# ADA COUNTY DEPARTMENT OF ADMINISTRATION

**RFP13060**  
**Ada County Landfill Hydrogen Sulfide Scrubber Project**

**ADDENDUM NO. 1**

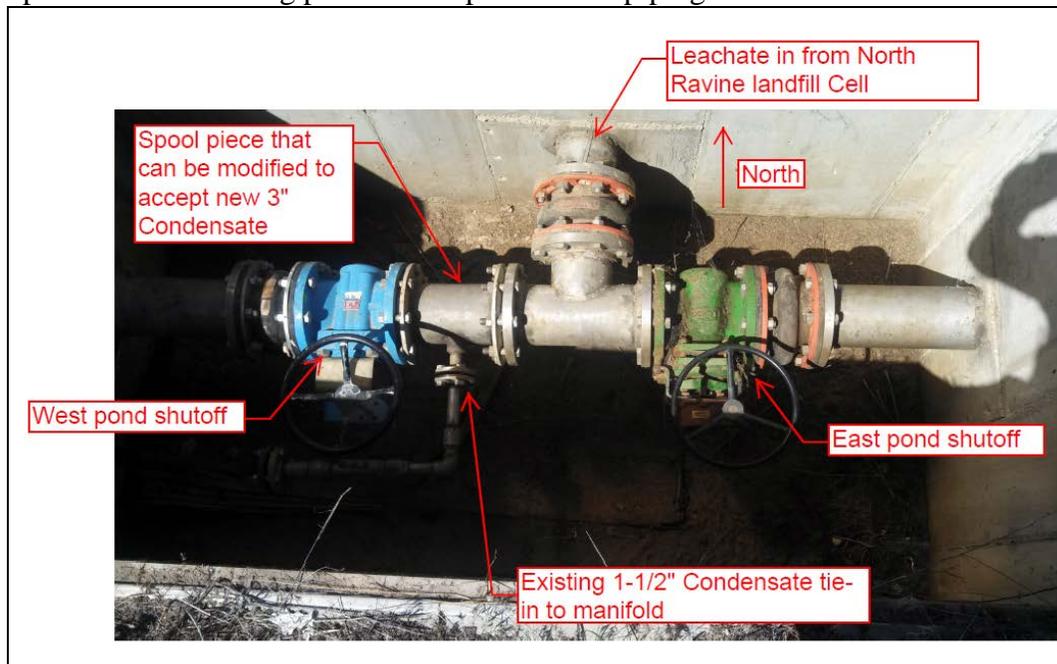
2. During the site tour on 06/25/13 the leachate/condensate valve vault lid was not opened. The following photo markup shows the piping in the vault:

The new 3” condensate pipeline may enter the vault on the east end (opposite current location) if the Contractor so desires. There is no reason the new pipeline needs to circle the vault as the existing one does.
